Response to Comments

Section 12A Application No.A/I-DB/3 for Optimisation of Land Uses at Area 10b, Discovery Bay  
Applicant's response to the departmental comments made available by District Planning Office on 6, 7, 12, 14, 20, 22, 25 and 29 April 2016

**Section 12A Application No.Y/I-DB/3  
For optimising land uses at Area 10b, Discovery Bay  
Response to Comments**

**Annex B**  
**Revised Concept Plan**

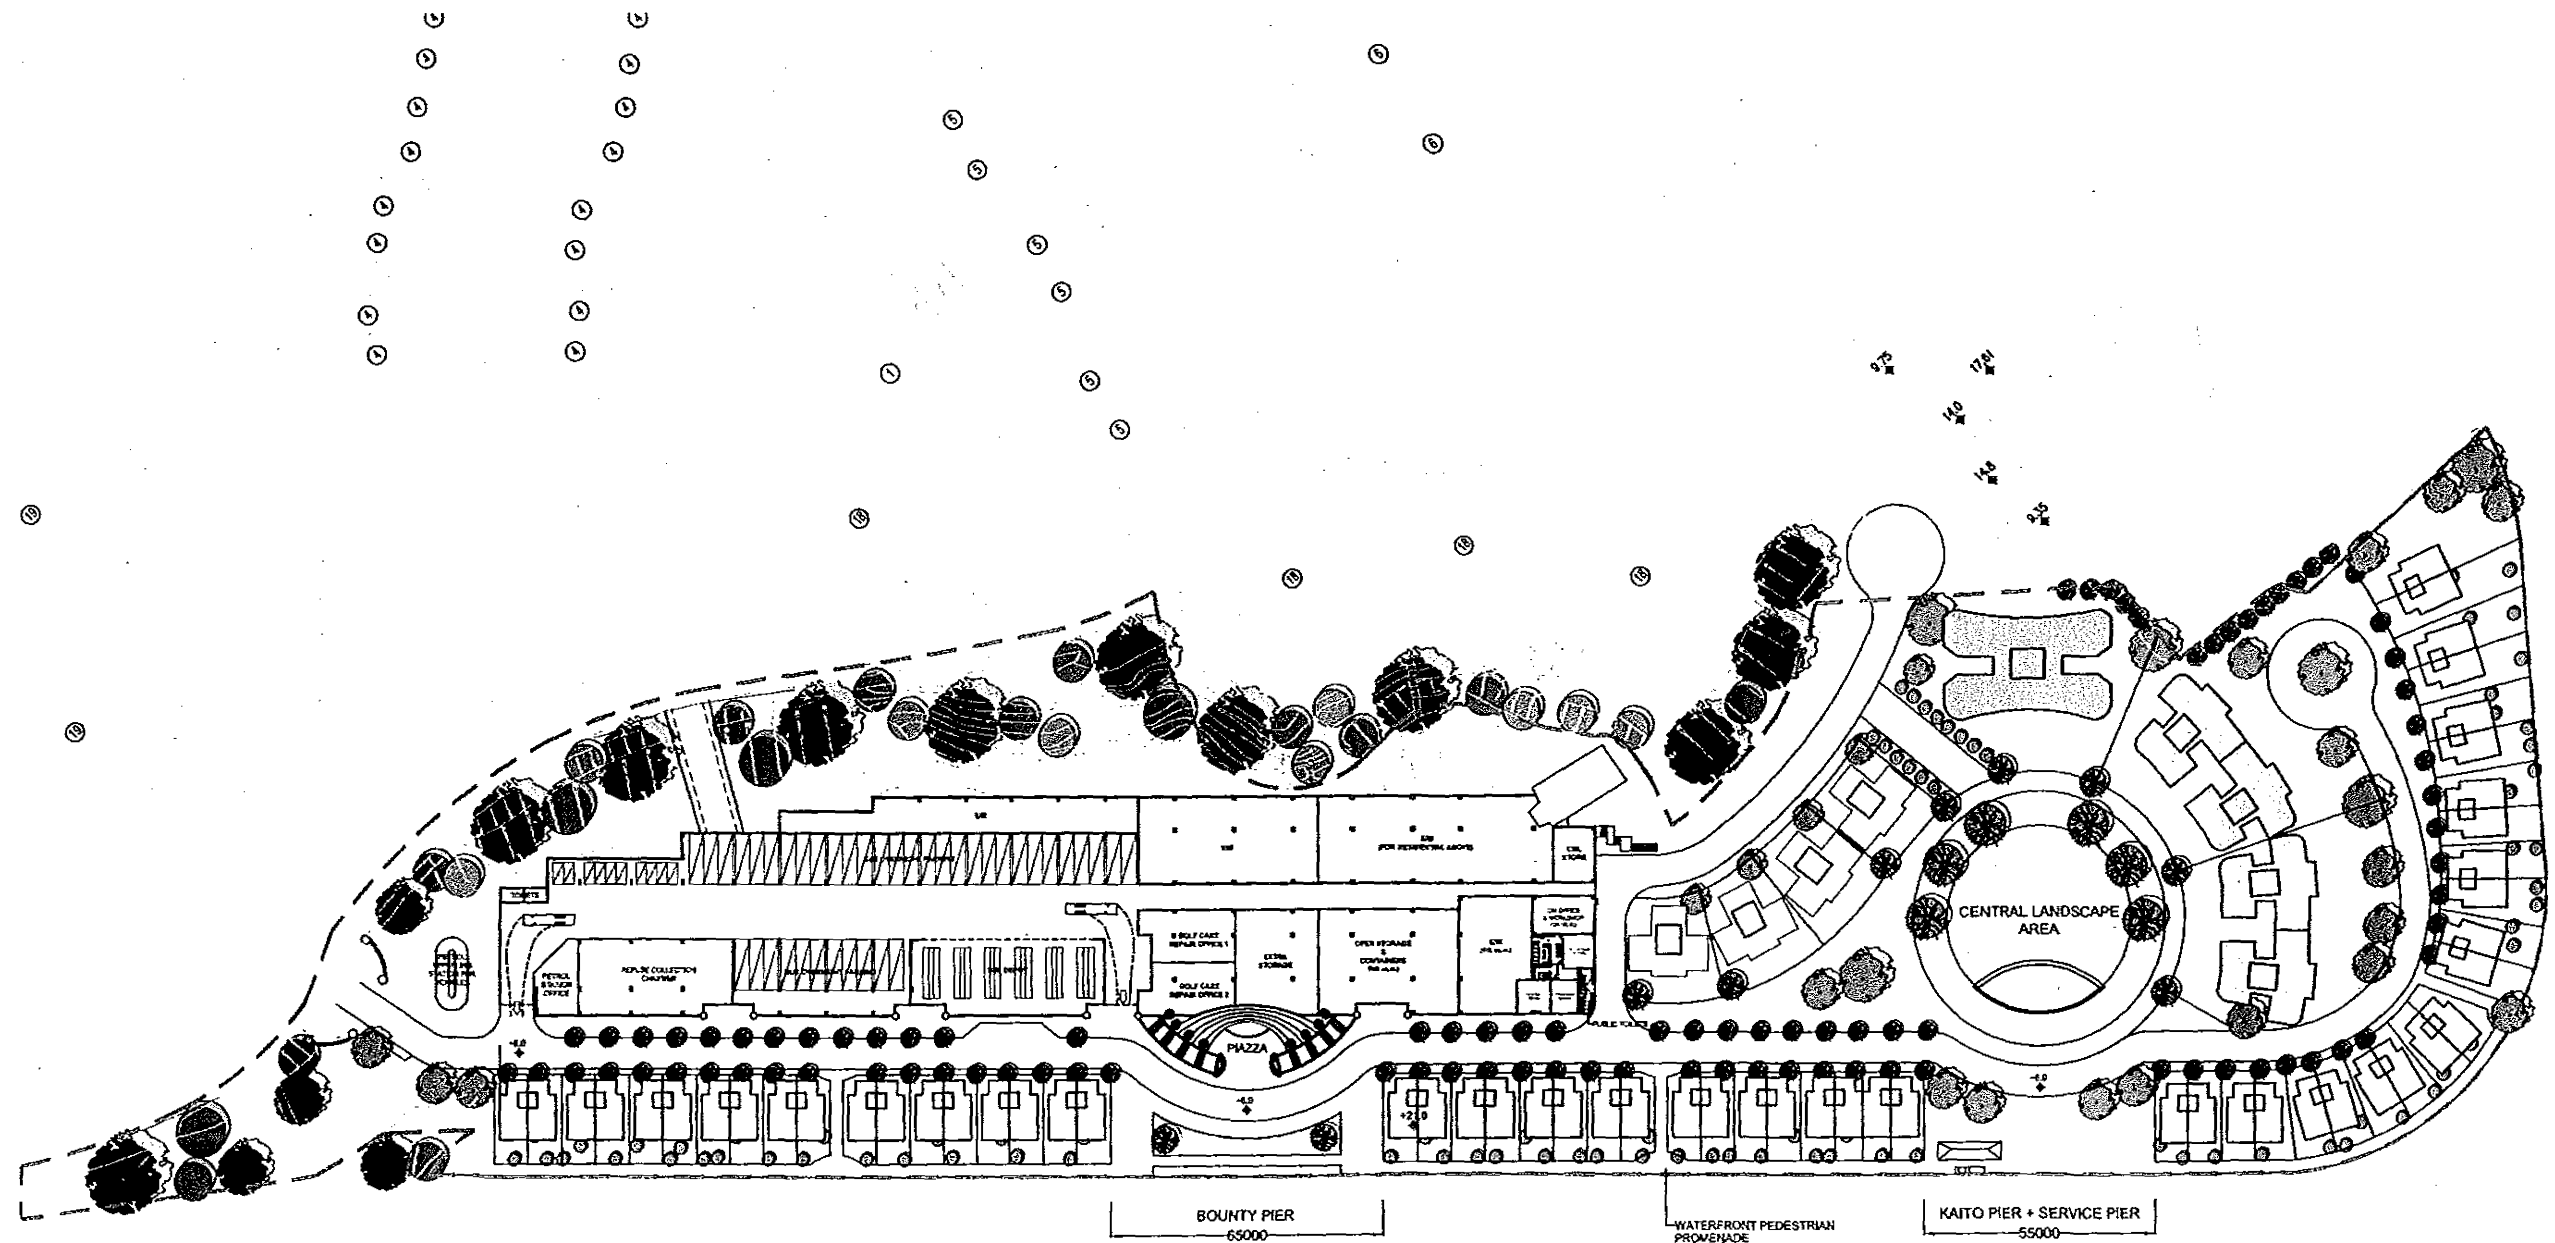
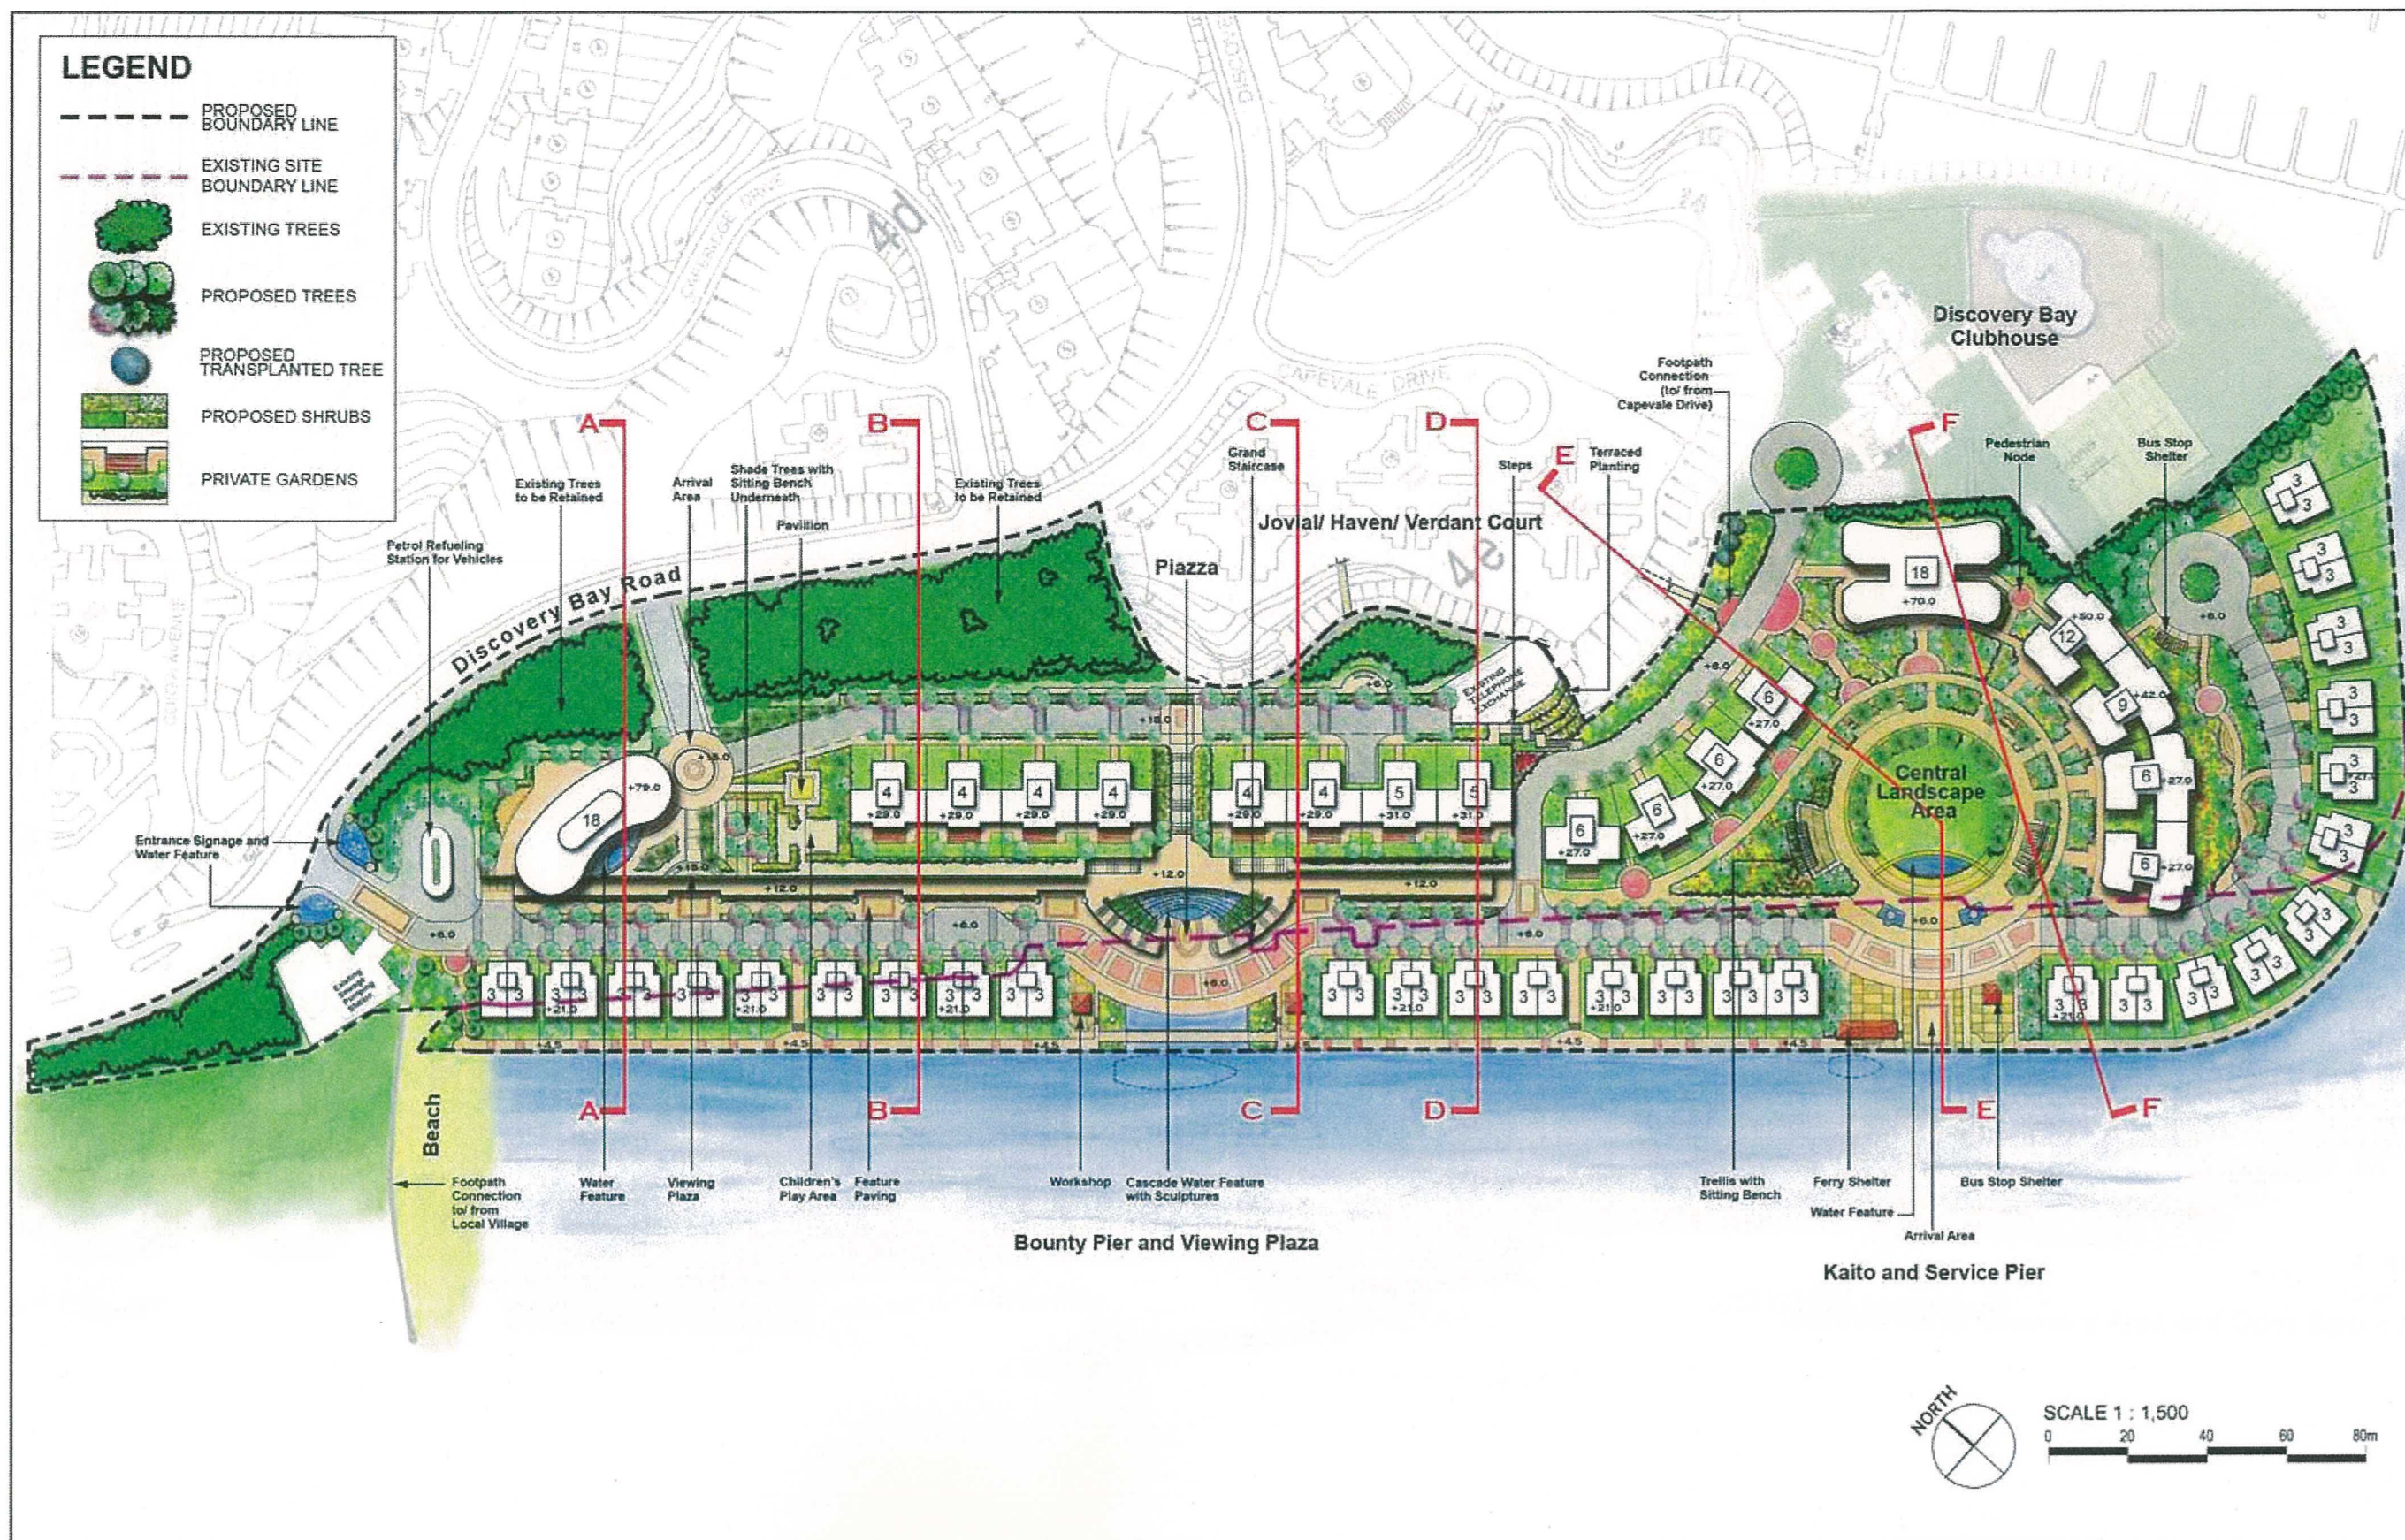
CTP/UD&L's comment	Applicant's response
According to the planning statement, the proposed development with a site area of 6.2ha, consists of 74 domestic blocks with maximum building height ranging from 21 to 86 mPD, together with an extensive podium of 9m in height and 260m in length. In view of the scale of the development with long lot frontage along the waterfront, there may be potential air ventilation impact on the surrounding area. However, in the absence of any technical assessment submitted by the applicant on this aspect, we are not able to ascertain the air ventilation impact brought about by the proposed development under the rezoning application.	Reference is made to Hong Kong Planning Standards and Guidelines (HKPSG) paragraph 10. It provides that Air Ventilation Assessments are applicable to major Government projects to assist planning at the macro-level. Proponents of private projects are encouraged to have regard to Air Ventilation Assessments, on a voluntary basis. It also provides that the focus is on pedestrian wind environment in the public realm at the macro-level. In view of HKPSG, the proposed private project at the private Area 10b land area is not strictly subject to the requirement for Air Ventilation Assessment.  Nevertheless, the Concept Plan for Area 10b has taken into consideration of air ventilation, and is considered to be capable of facilitating suitable air movement generally in accordance to HKPSG, as discussed in Annex A.  The Concept Plan is indicative in support of the rezoning proposal with room for improvement at detail design stage. Under a revised Concept Plan (Annex B, also including updated Podium Ground Floor Plan and Landscape Master Plan reflecting the revisions), the building dispositions of M2, M3 and M4 have been adjusted to create a 9 metres wide building separation.

**GREENERY AREA**

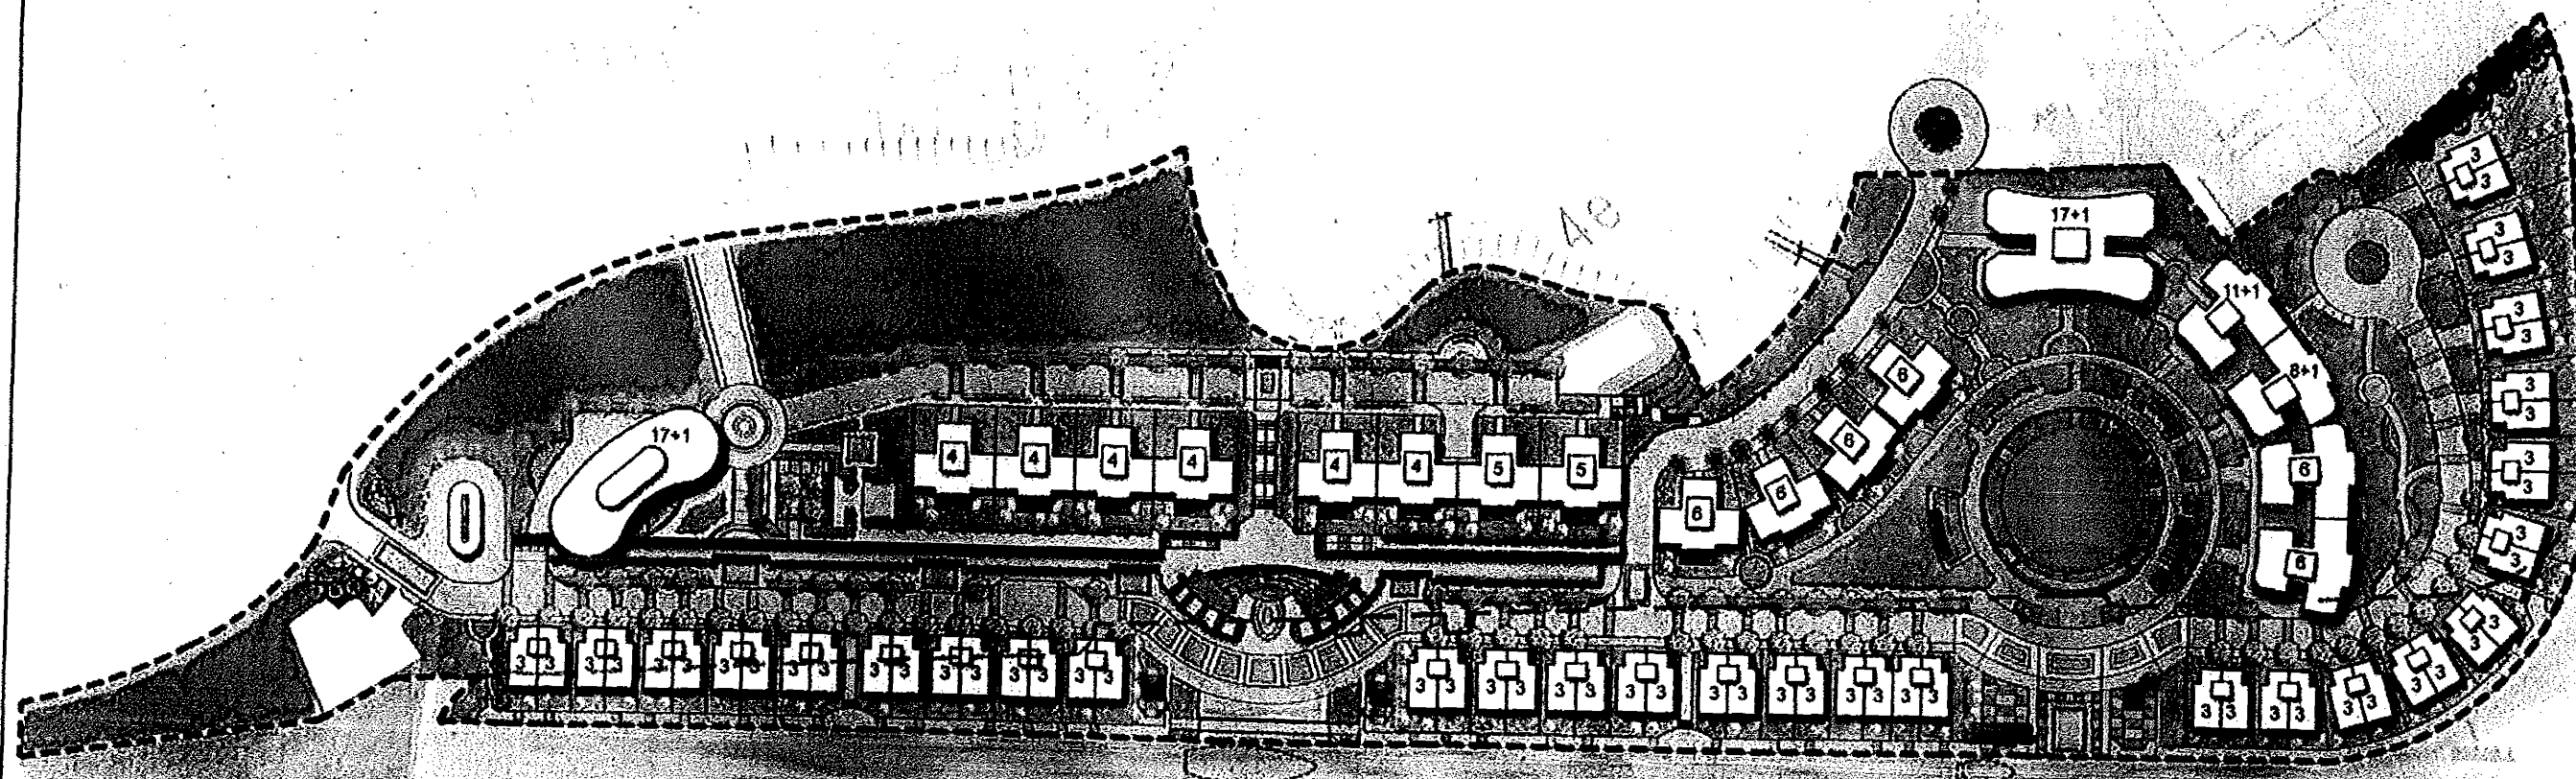
<p>(iv) The proposed waterfront promenade seems to be too narrow in width. It should be extended beyond the Kaito Pier to the east of the tennis court. The Applicant should demarcate clearly the private and public zone in the development. The promenade is advisable to be open for public enjoyment.</p> <p>(v) There are many changes in levels on the Master Layout Plan, the applicant should ensure that the common areas are all barrier free accessible in the detailed design.</p> <p>(vi) As shown on the Sections of Figures 7a to 7b, slopes are found at the northern part of the Site. Site formation and slope stabilization work may be required for the development. In this regard, please consider a balanced cut and fill design to reduce the burden on the public fill.</p> <p>(vii) In line with Government's initiative on more greening in development, it is advisable to provide 30% green coverage within the proposal.</p>	<p>Nevertheless, a revised Concept Plan (Annex B also including updated Podium Ground Floor Plan and Landscape Master Plan reflecting the revisions) incorporates the following to better address the concern:</p> <ul style="list-style-type: none"> <li>Stepped down the walkway level along the podium edge and thereby make it more human scale.</li> <li>Widened separation between the two buildings around the piazza, to 15metres to allow a more significant visual corridor between the greenery slope and the waterfront.</li> </ul> <p>Due consideration will be given to enhance the building typology, elevation, building gaps and façade treatment at detail design stage.</p> <p>The waterfront promenade, together with the two plazas and central landscape area, will serve local residents and visitors. This is as per the existing open spaces arrangement at Discovery Bay.</p> <p>The revised Concept Plan in Annex B also incorporates the following to better address the concern:</p> <ul style="list-style-type: none"> <li>Three paths through the houses, in addition to the two plazas, for better access between Marina Avenue and the waterfront.</li> <li>The parts of the promenade around the new paths are widened to about 5 meters, to create nodes and add interests along the length.</li> <li>An extension to east of the kaito pier, which is a logical termination as it leads users to the communal garden east of Towers L1 and L2 and the bus stop gathering point further to the north. The waterfront around the Marina is of a different character, being a private and separately managed area not currently open to the general public, and security of access should be maintained. As such, further extension of the promenade to this part is avoided.</li> </ul> <p>Noted. Common areas will be barrier free accessible in accordance with relevant building codes.</p> <p>Noted. Construction methodologies are yet to be decided, careful considerations will be given to reduce the burden on public fill.</p> <p>Noted. The proposal is capable of complying with Sustainable Building Design Guidelines' greenery requirement.</p>
